Memorandum

Subject: Evaluation of Petition No. 574 to amend title 8 section 1604.5

Picture 1. Anchor for an elevator hoist structure

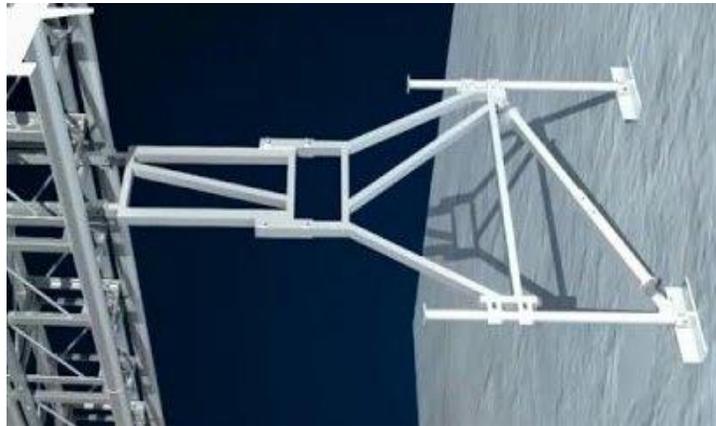
Subsection 1604.5(d)(3) does not contain requirements regarding the location of anchor points, but rather requires the elevator tie-ins to be in conformance with or equal to the manufacturer's specifications. Pictures 1 and 2 illustrate examples of an anchors and tie-in respectively.

The petitioner's argument that these two subsections conflict does not have merit as it conflates two separate requirements that refer to different components used to secure a construction elevator tower.
